RE: Addendum #001 - PC Asphalt Repairs Parking Lot A&B (Gates)

Addendum #001 has been issued to reflect the following updates/changes to the bid documents.

Figure 2: interior of electrical vault

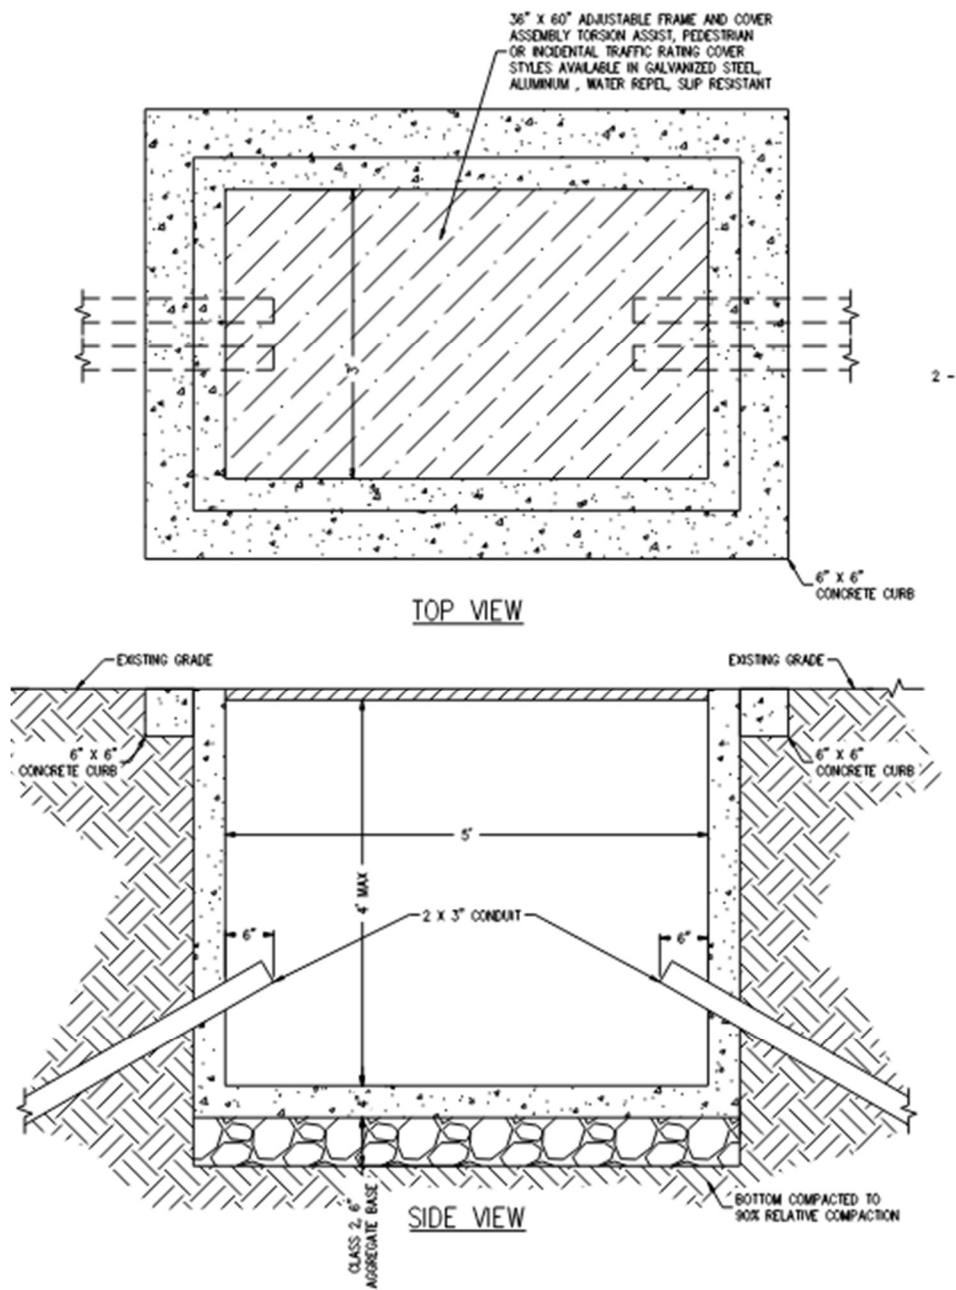
4. Electrical Vaults: Below are pictures of the interior of each of the electrical vaults that the contractor will be required to lower at the south end of the project. Contractor should assume that the entire box will have to be removed and replaced, as the existing boxes have no removable rings. The lid may be reused if it is not damaged during removal. The boxes will be required to be re-installed per the details given below.

Figure 4: Large Box install detail

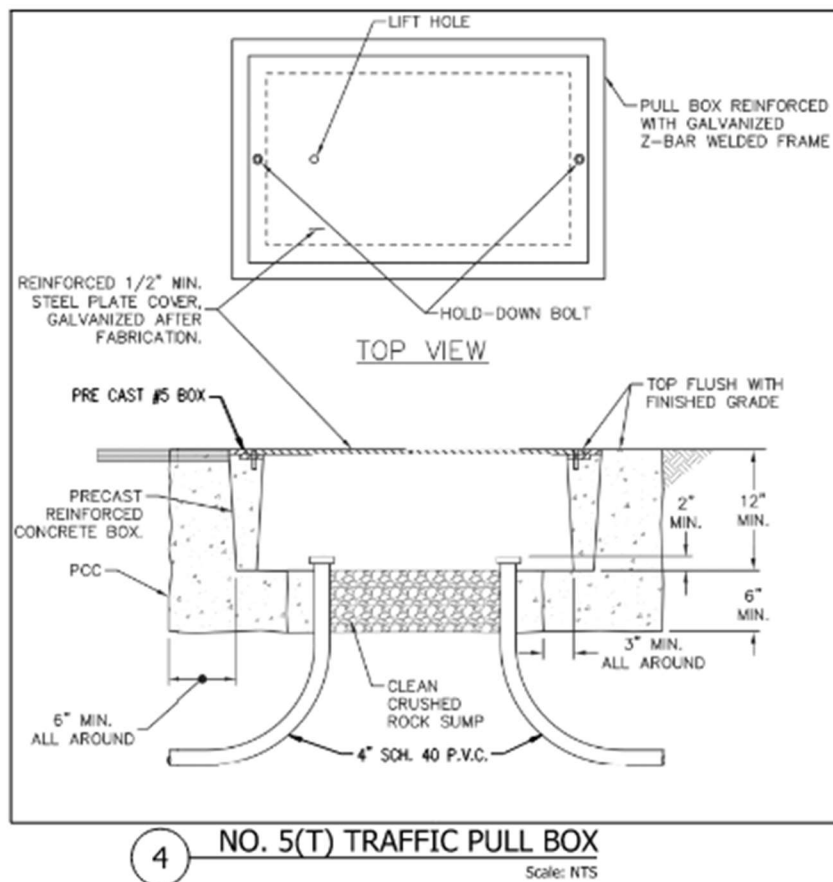
Based on the survey data we have, we estimate that the large vault will need to be lowered 0.5 feet, and the small vault will need to be lowered 0.7 feet.
